UNITED STATES PATENT AND TRADEMARK OFFICE

Office Action Summary	Application No. 10/528,706	Applicant(s) BEGUERY ET AL.	
	Examiner STEPHAN ESSEX	Art Unit 4111

DETAILED ACTION

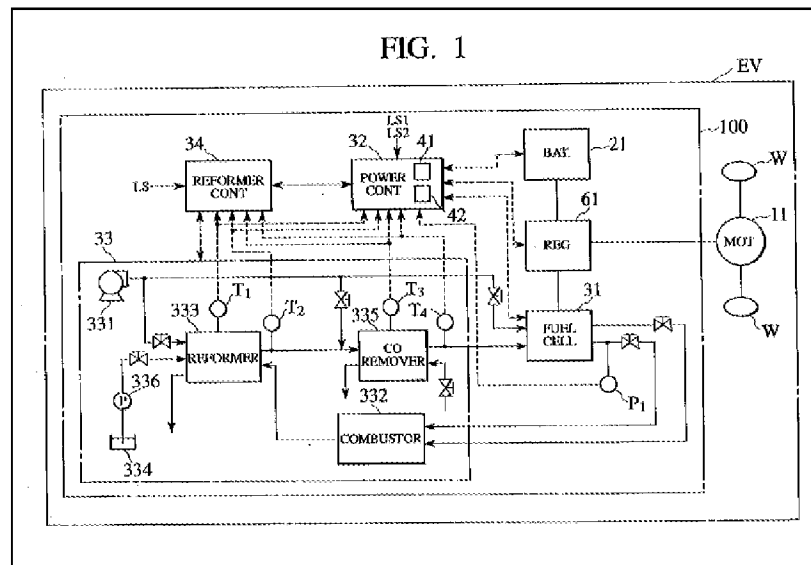
a) a balance during which a potential electric power that fuel cell is capable of instantaneously supplying is calculated in accordance with the fuel flow produced by the reformer (reformer 333) (see paragraphs 30, 40, figure 1).

Regarding claim 13, Kobayashi teaches that the remaining portion of excess fuel is burned off (combustor 332) (see paragraph 34, figure 1 above).

Regarding claim 15, Kobayashi teaches the use of electric batteries (secondary battery 21) for energy storage (see paragraphs 14 and 26, figure 1 above).

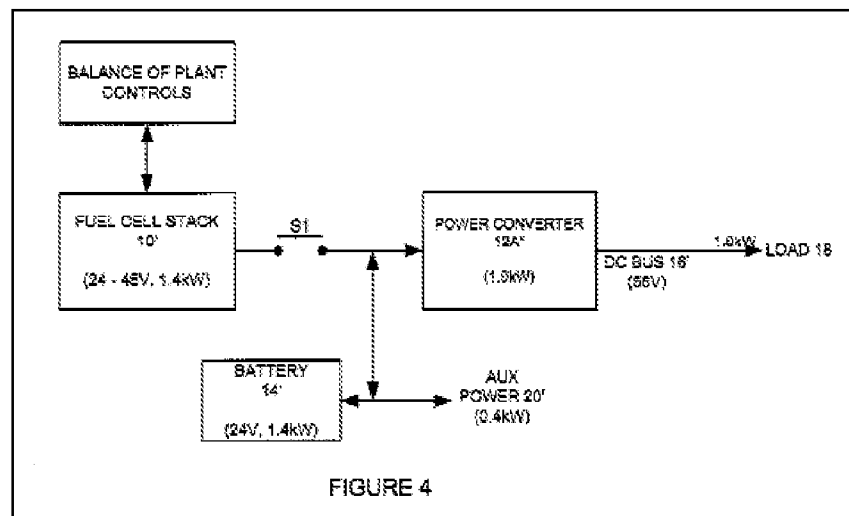
Jungreis teaches that is known in the art to calculate excess electric power as the difference between potential electric power and the sum of electric powers consumed (load 18) (see paragraph 16, figure 4). It is therefore implied there are means for estimating the sum of electric powers consumed.

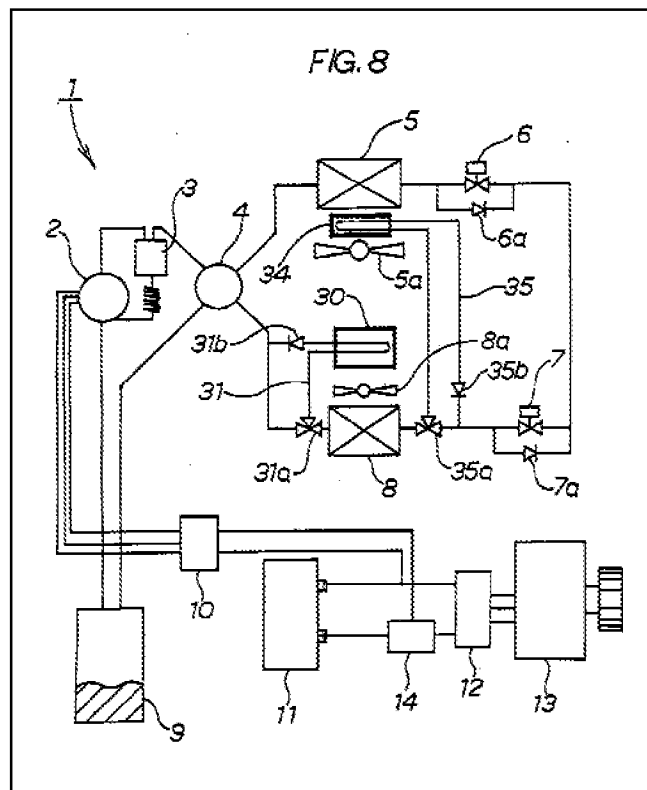
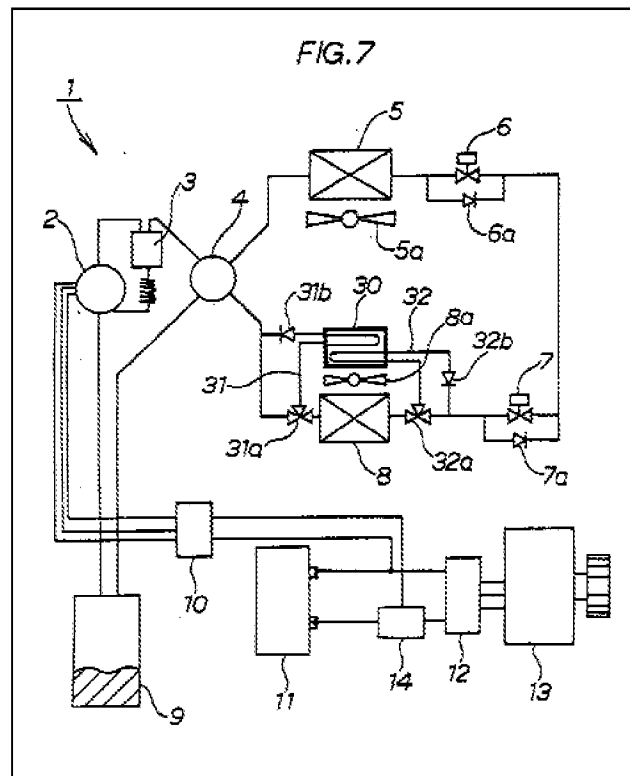
Seto teaches energy storage in the form of a heat accumulator (heat accumulating means 30, 34) in which the excess electric power (excess regenerative power) is stored in a form of heat energy by a compression cooling system (compressor 2) (see abstract, col. 5, lines 55-58, col. 6, lines 1-8, figures 7 and 8).
